Continued problems with the assessment of the hydrologic effects of the proposed TPM LLC mineral sands mine and a recommendation for an independent expert panel.

Dr. C. Rhett Jackson, John Porter Stevens Distinguished Professor of Water Resources, UGA.
3/27/2024

III. EPD's modeling of the Swamp as a Level Pool Reservoir of Water (Page 9 of the November 16, 2023 EPD Memo: "Summary of hydrologic analyses on Twin Pines Mineral's (TP's) Charlton County project")

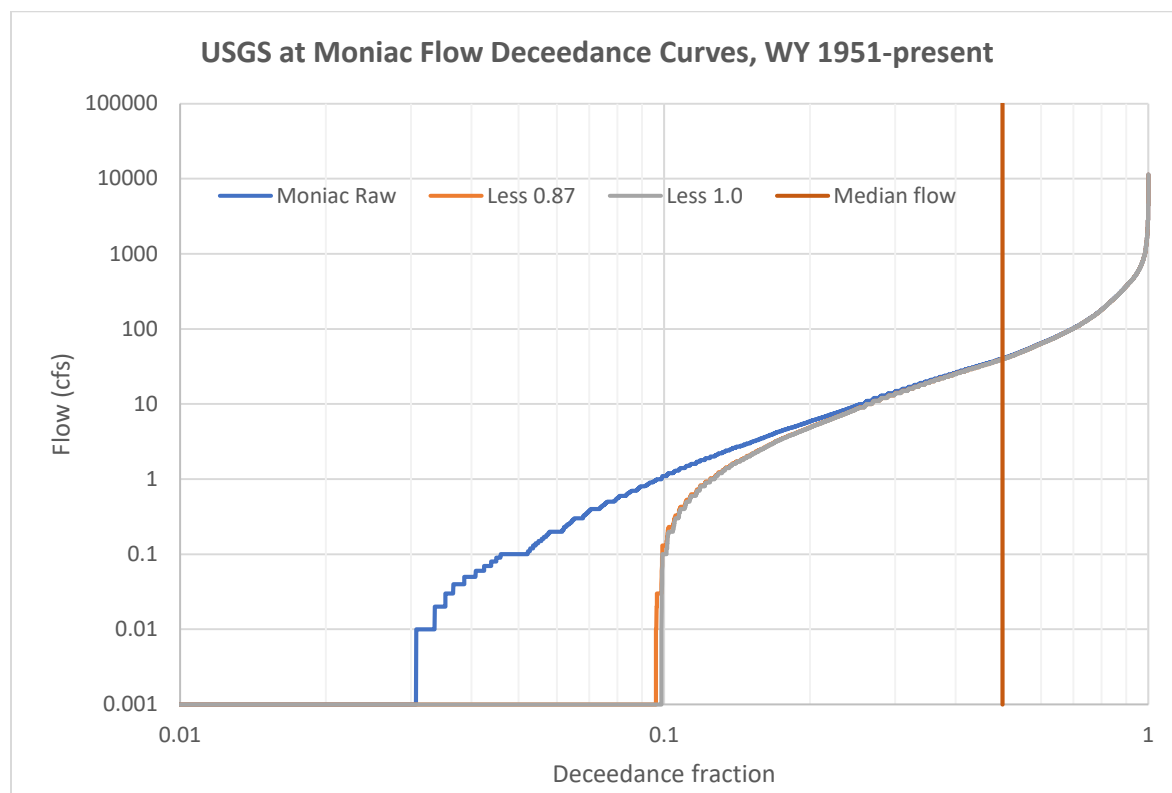
To estimate the effects of this consumptive groundwater withdrawal on the swamp, we can subtract 0.87 cfs from all historically recorded streamflows for the St. Marys River as it leaves the swamp, and compare the cumulative distribution of flows with and without the subtraction (see graph below). This is how EPD evaluates the effects of consumptive use applications around the state. We can see that the withdrawal has no effect on median flows, and it really doesn't change hydrograph behavior until flows drop below 10 cfs. However, *this relatively small withdrawal has very large effects during drought periods, and it would triple the duration of zero-flow periods (from 3% of the time to over 9% of the time). Essentially, robbing 0.87 cfs from the St. Marys compartment of the swamp will make drought conditions more frequent and more severe.* EPD has pretended this doesn't matter, but to do so, they have had to use a different method of assessing the consumptive use effects than they use for other consumptive use applications in the state. *Why does this method make sense everywhere else but not here? How does a 0.87 cfs reduction not matter if the flow is less than this value 7% of the time?* (See Appendix B, Letter from 13 southeastern hydrologists stating that the hydrologic effects of the mine should be assessed from the Moniac gage flows)

The above flow-deceadance curve shows the fraction of time that river flows are below any given level. As an example, for the raw flow data from the Moniac gage, the St Marys River flows are less than or equal to 1.0 cfs for 10 percent of the time (1/10 of the total flow period). This curve was created using the USGS-measured streamflow record for the Upper St Marys River as it leaves the swamp (USGS gage 02228500). The curve shows that the undisturbed river has no measurable flow for slightly more than 3% of the gage record, indicating the sensitivity of the swamp to drought. Previous analysis has shown that flows at this gage are highly correlated with US FWS-measured water levels in the swamp (Hyatt, PhD dissertation, Univ. of Georgia, 1984). The plot also shows flow-deceadance curves for a narrow range of consumptive water withdrawals from the swamp; 0.87 and 1.0 cfs. The 0.87 cfs loss equals half of the necessary pumping for mine pit dewatering, and this is the minimum potential effect of the mine. The larger withdrawal cases reflect an additional possible loss up to 0.13 cfs due to increased leakage from the swamp due to Floridan

Aquifer pumping by the mine. Unlike the pit dewatering, Floridan pumping will be episodic, but the mine documents estimate average consumption will be 0.43 MGD or 0.67 cfs. TPM documents argue that there will be no leakage from the swamp to the Floridan aquifer, but that is an assumption in the model. It is not based on data or modeling of leakage. Note: both axes are on log scales, which is done in hydrology when data vary by several factors of 10.
